CONCEPTUAL MODEL EVALUATION (UPDATE)

**Nevada Nuclear Waste Storage Investigation
Subtask 1.4 Report #2**

**TECHNICAL ASSISTANCE IN HYDROGEOLOGY
PROJECT B - ANALYSIS
RS-NMS-85-009**

Re: Subtask 1.4, Conceptual Model Evaluation (Update)
Letter Report for Contract NRC-02-85-009 (WWL #4001)
Technical Assistance in Hydrogeology - Project B - Analysis

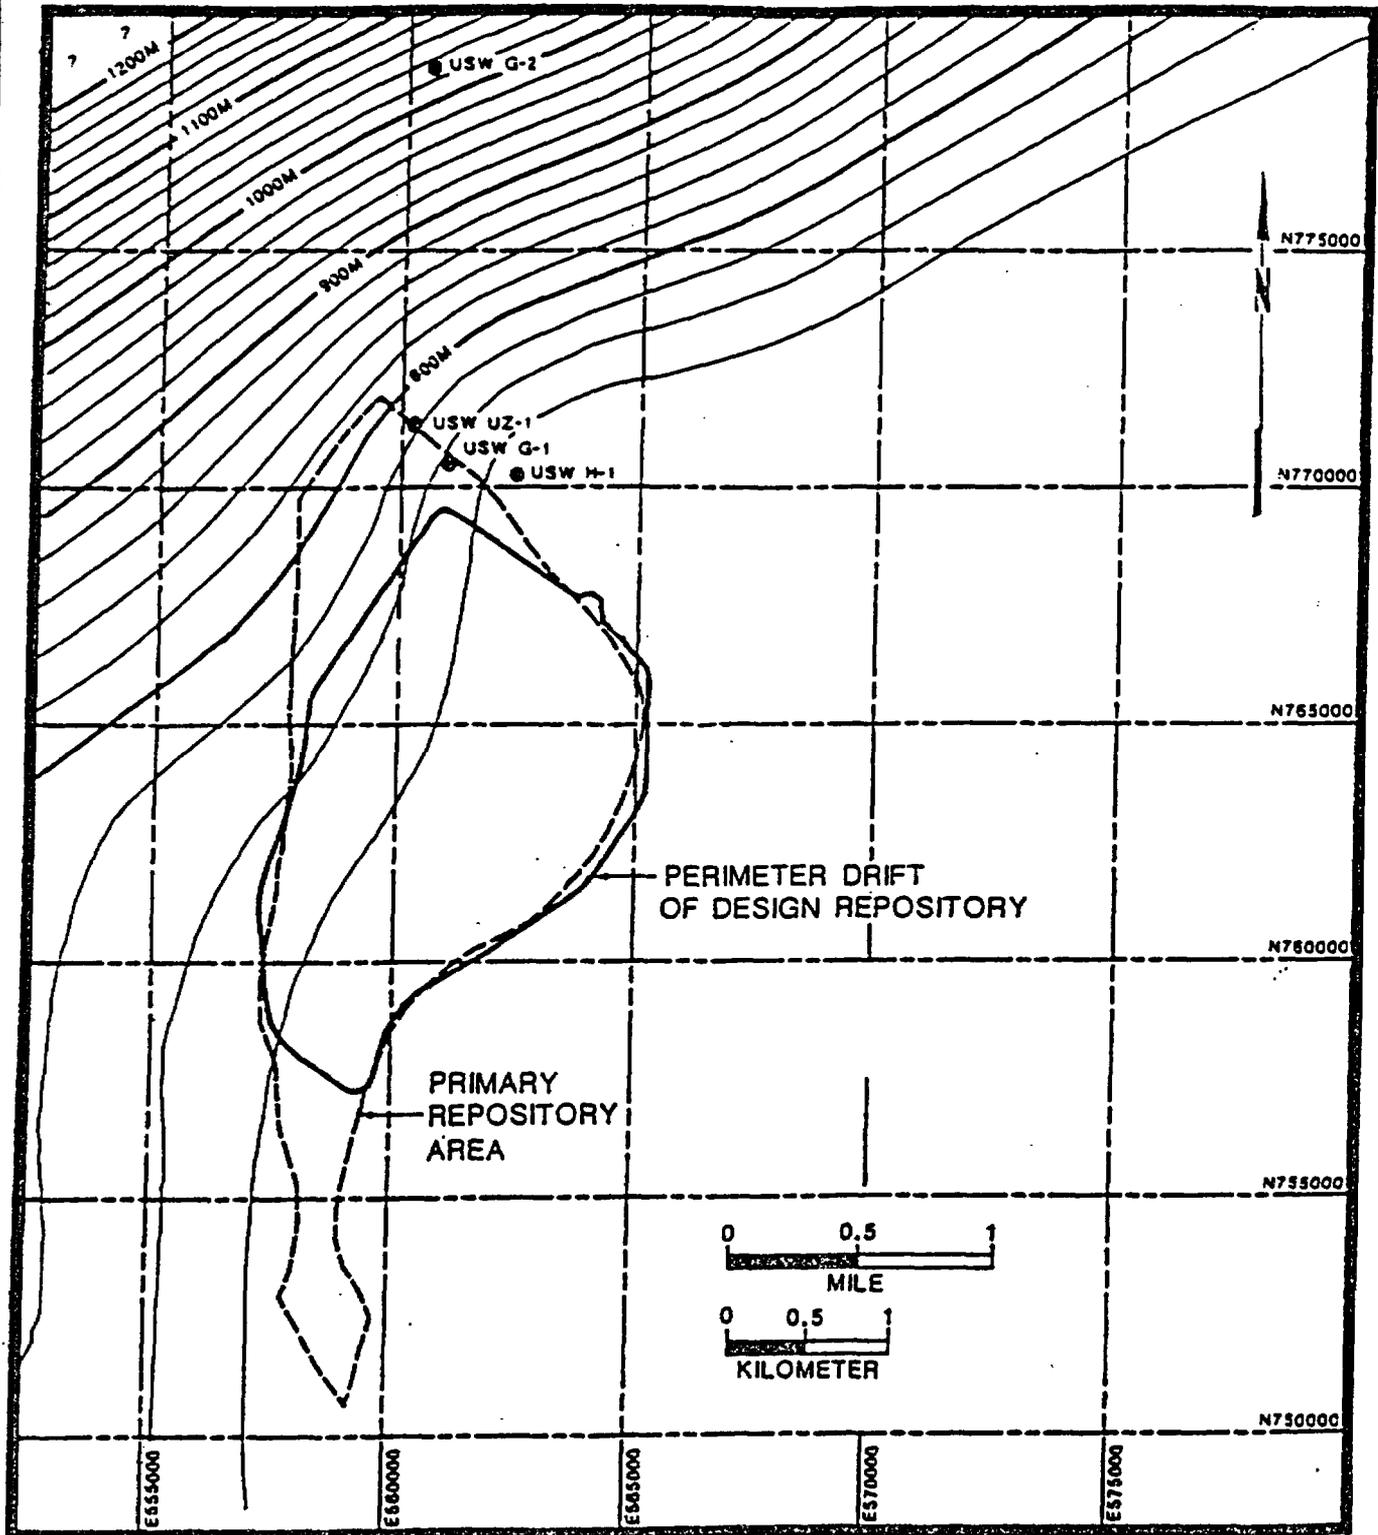
Several holes have been drilled in the vicinity of Yucca Mountain during the past several years. The holes which provide the information on which the following discussion is based are listed in Table 1 along with pertinent physical data for each of the wells. Approximate well locations relative to the primary repository block are shown on Figure 1 which also demonstrates the current DOE piezometric surface map.

WATER LEVEL ELEVATION

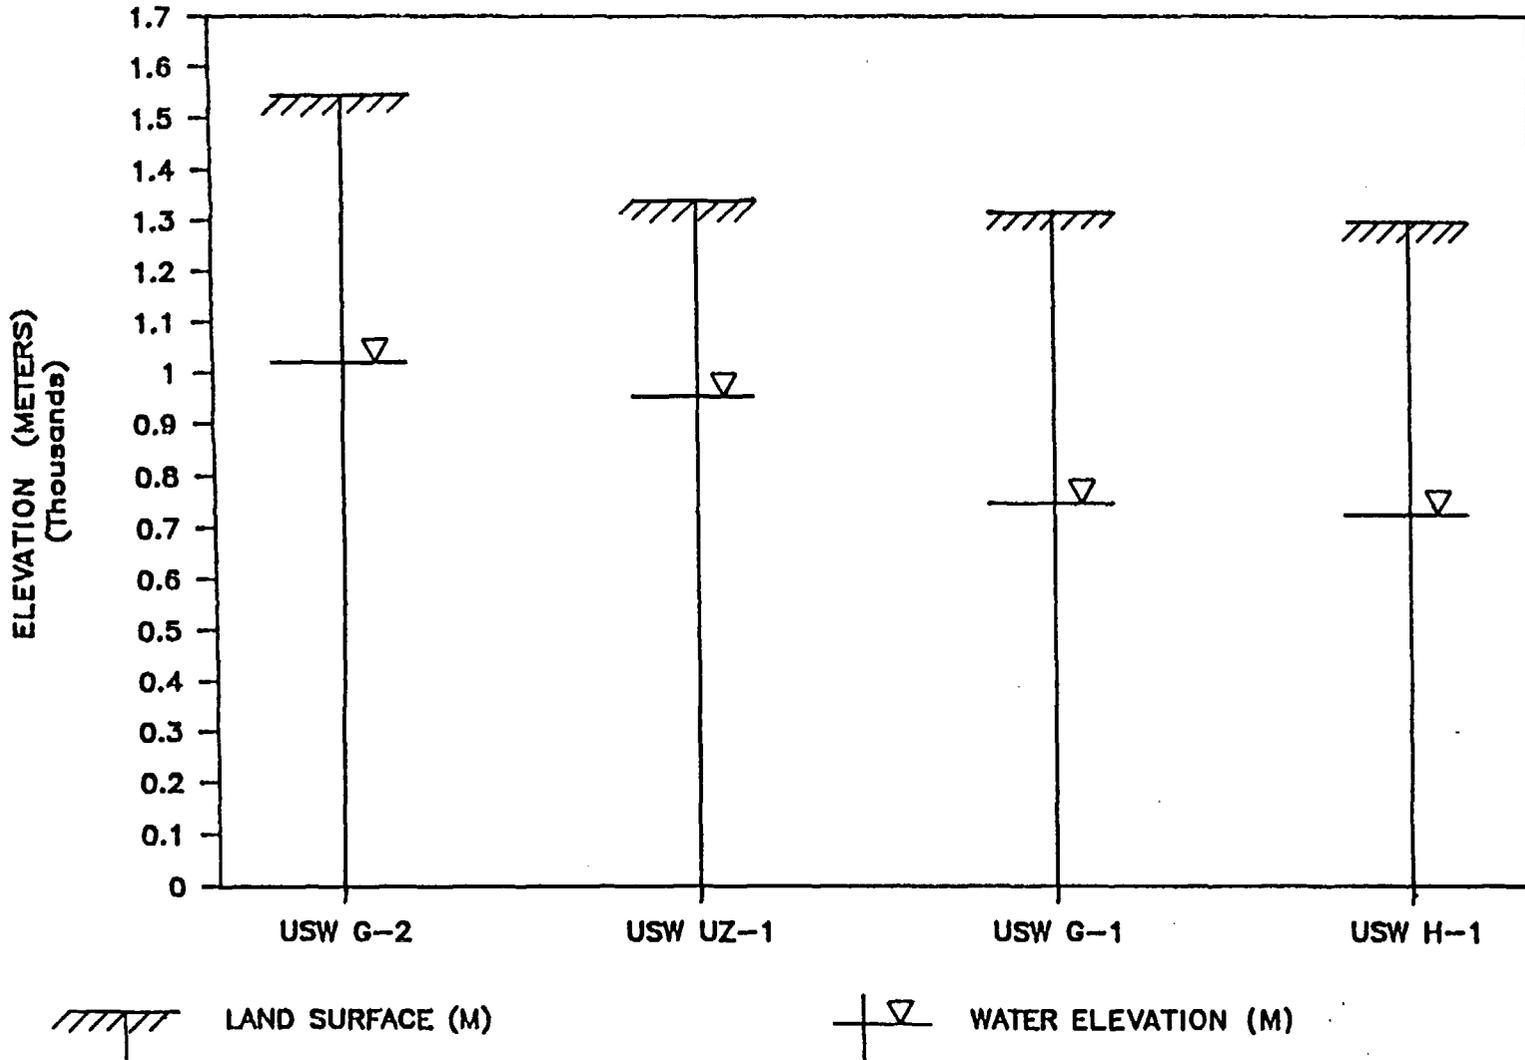
Encountering the water in USW UZ-1 at an elevation of 963 m which is significantly higher than the predicted elevation of about 780 and the determination that the water contained drilling fluid polymer from a well 305 meters away (USW G-1) raises serious questions about the fracture network in the Topopah Spring welded unit. First, fluid has moved laterally a significant distance, and secondly, the water has not rapidly "drained" through the unit. Since UZ-1 was completed in October, 1983, a period in excess of three years was available for the water from USW G-1 to drain from the fracture system. It has been postulated by the DOE that the drilling fluid "lost" during the drilling of borehole USW G-1 formed a perched water zone extending to borehole USW UZ-1.

If the water found in USW UZ-1 is indeed perched, then the Topopah Springs welded unit may not be as free draining as anticipated by the DOE. If the repository is placed in the Topopah Springs welded unit, the possibility of a saturated zone encompassing the waste at some point in the future may then exist. The saturated zone may be caused by increased infiltration due to a change in climatic conditions or due to a condensed layer of water formed by the heat load from the canisters. After condensing, the water could move downward and eventually pass through the repository layer.

If the water at USW UZ-1 is not perched, but is indeed the water table, then the water table altitude contours presented by the DOE in the EA would need to be radically changed. Based on the above discussion and information available thus far, the DOE has not proven conclusively that the water found at USW UZ-1 is perched. In the event that the water located in USW UZ-1 is the water table at that location, then it will probably be important to determine the reason for the large gradient which exists between the two wells, UZ-1 and G-1. Water levels (assuming the water in UZ-1 is the water table) along with surface elevations are depicted schematically on Figure 2 to demonstrate the change in gradient between the two wells.

Information obtained during the drilling of the USW UZ-1 well as to the amount of water pumped, drawdown during pumping (if any), and length of time the well was pumped before the decision was reached to cease drilling operations may give insights into the anomaly. This information may lead to the need to further characterize the Topopah Springs welded unit and the water table at the area near USW UZ-1.
